Justification for modifying FTMs

bolla@fnal.gov for the CDF Silicon Group

Figure 1: schematic of the FTM board with in BLUE the resistors to be replaced and in RED the JUMPERS to be inserted.

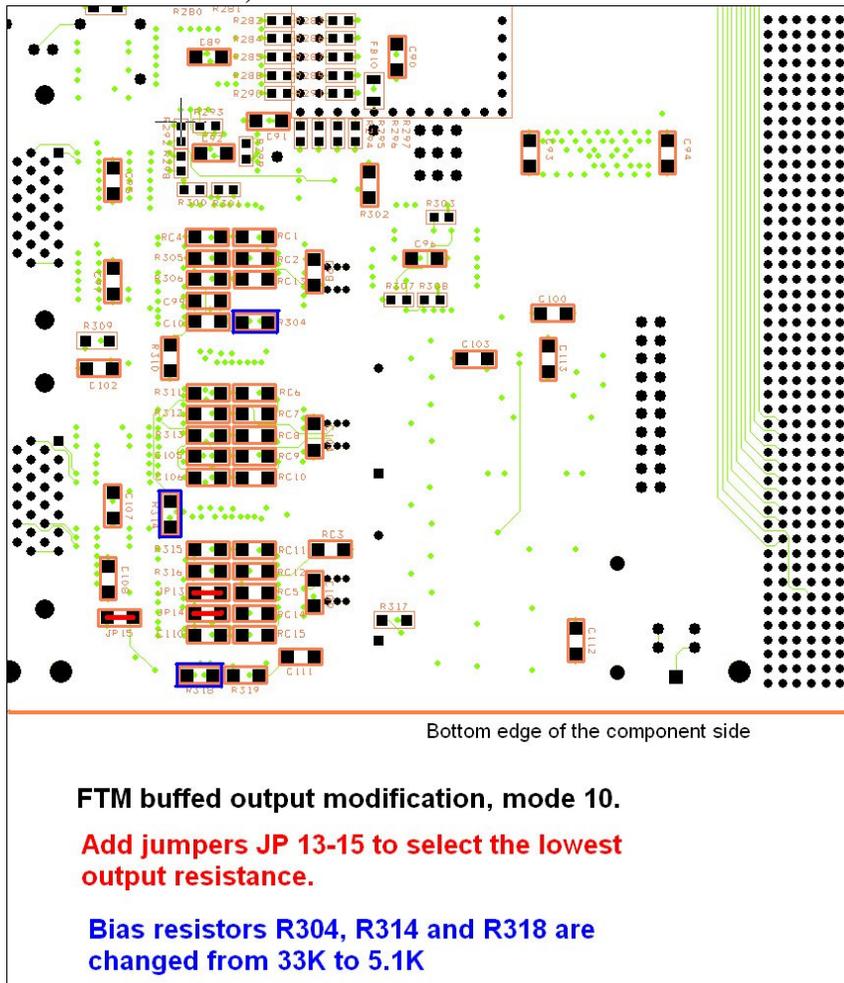
1. Unplug the FIB timing cables (2) and the fibers (10) from the FTM board and removal of the FTM board from the VME crate. (Time needed 10 minutes)
2. Modify the FTM board according to the drawing in figure 1. Three resistors have to be replaced (from 33 K Ω to 5 K Ω) and 3 jumpers have to be added.(Time needed 15 minutes)

Figure 2: LEFT, differential signals as produced by a *regular* FTM, RIGHT differential signals as produced by a *buffered* FTM.

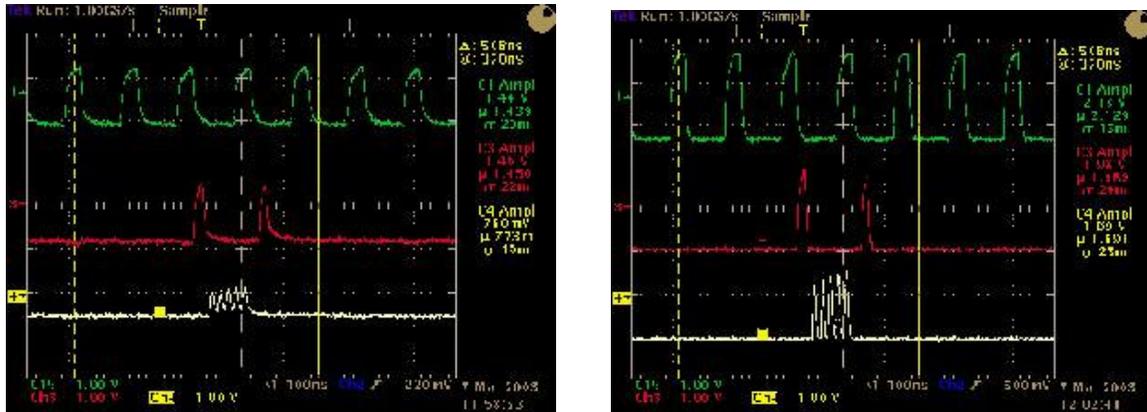
The tools are now in place (and a JHA as well) to perform the work in the collision hall. This work can be pipelined up to a throughput of 1 board every 30 minutes. The impact on the signals quality can be seen in Figure 2.
